BHEL Reply to Pre-Bid Query_ 21.09.2022					
Name of the Work: "Hiring of 800 MT Crane for Incinerator Vent Stack Erection Works in (525) TPD Standby SRU Project, IOCL Paradip Odisha". Tender ref no.: T0AVX00049_NIT-68294 in (www.bhel.com), dated 10.09.2022 Tender id in https://eprocurebhel.co.in : 2022_BHEL_17647_1					
Bidder Name	Sl. No	Clause	Tender Clause Description	Bidder's Query	BHEL's Reply
India Pvt. Ltd.	1	Annexure – I, Prequalifying Requirements / Page 2 of 10	C2: Net worth: Net worth of the Bidder based on the latest Audited Accounts as furnished for 'C1' above should be positive. C3: Cash Profit: Bidder must have earned cash profit in any one of the three Financial Years as applicable in the last three years defined in 'C1' above based on latest Audited Accounts. NET cash profit=(PAT + Non cash expenditure viz depreciation)	We request BHEL to review the Net worth & profit - Financial PQR requirements for crane hire Tender as contractor has to mobilize the crane which is contractor's asset and the same would be available with BHEL for complete contract period without any advance payment from BHEL. Further, all the payments will be paid by BHEL only after work completio

DEPT. (HEV) CODE	UNTL. DIMS. GR. G.M.F.		SCALE NTS	WEIGHT (KG) ---	REF. TO ASSY. DRG. -N.A.-	ITEM NO. -N.A.-	NO. OF ITEMS -N.A.-
TITLE GENERAL ARRANGEMENT VENT STACK				CARD CODE N.A.	2443-INC-DCI-037 CUST DRG NO. J885352-000005-PKG-A1001-016		REV 00
10			11		SHT. No 1	NO. OF SHT. 3	12

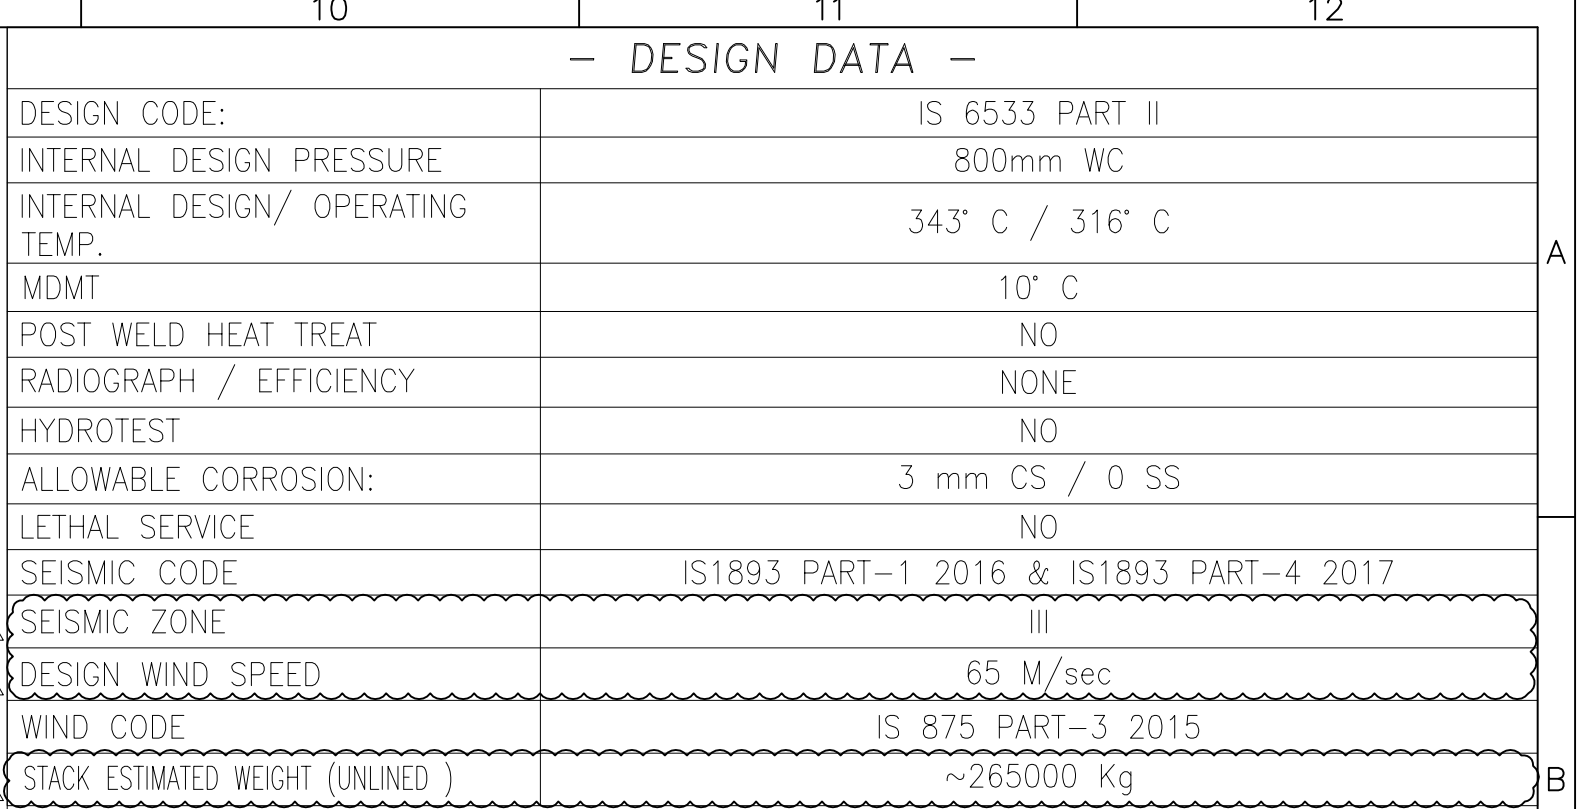
Zeeco shall revert this change and ratings for stack analysers shall be 150# only as marked below.

VENT STACK		N.A.	SHT. No 1	NO. OF SHT. 3
	12		11			12

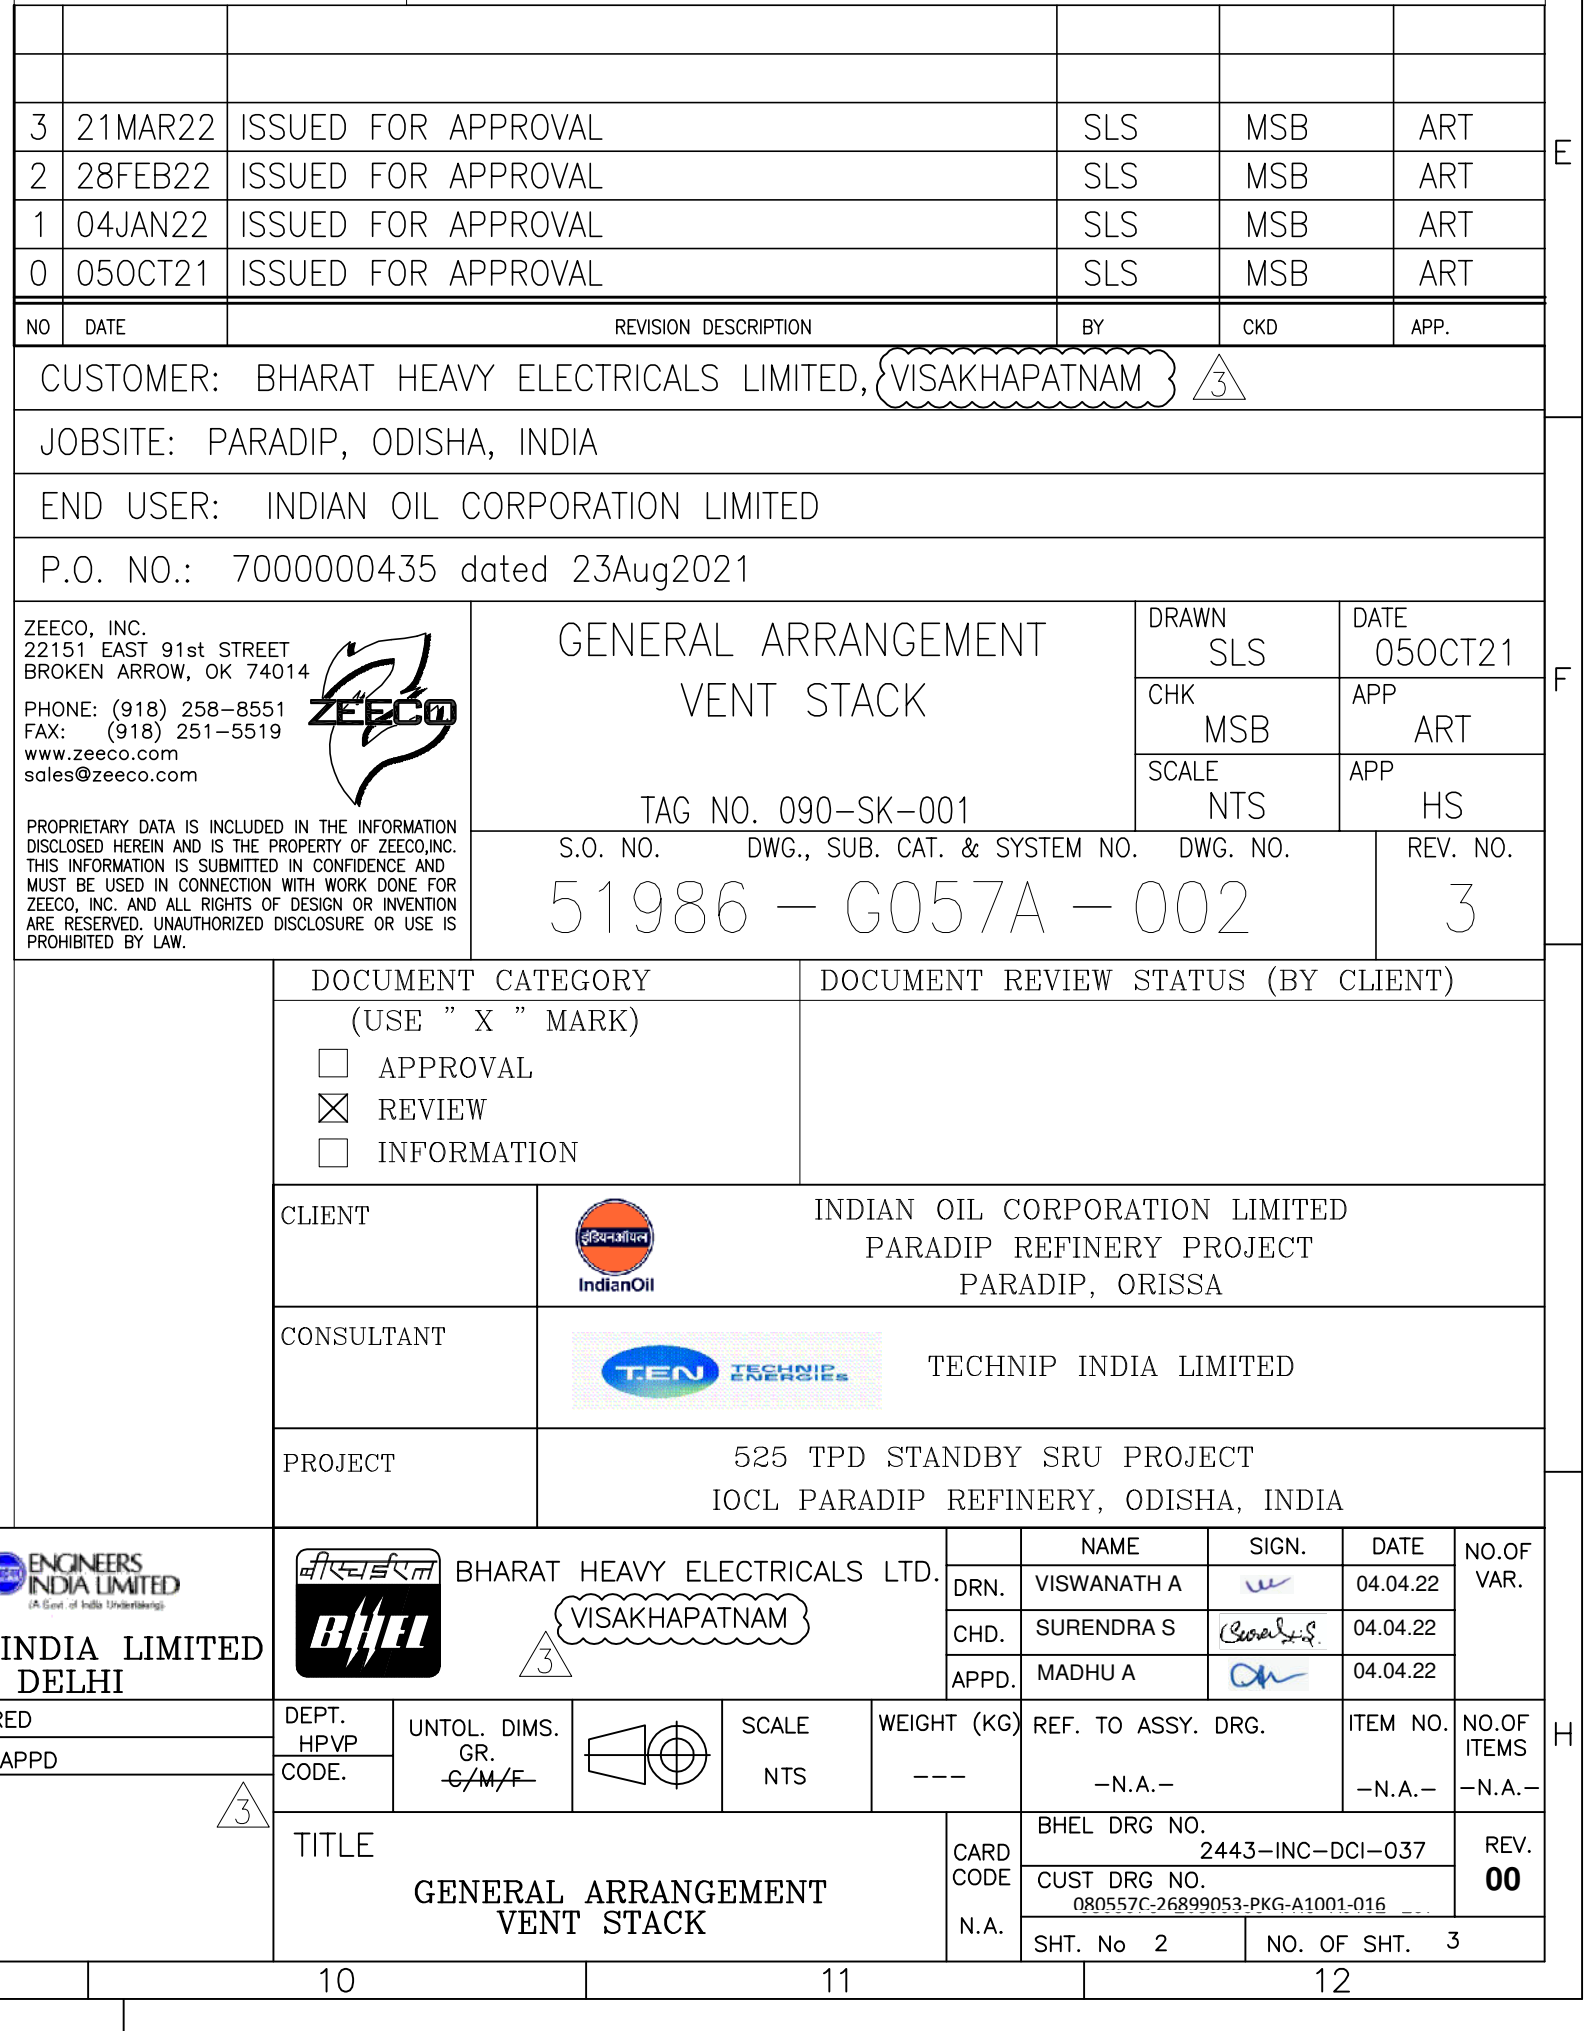
Except Aviation fixtures other lighting fixtures also to be shown for area lighting, in separate drawing

Drawing not found updated.
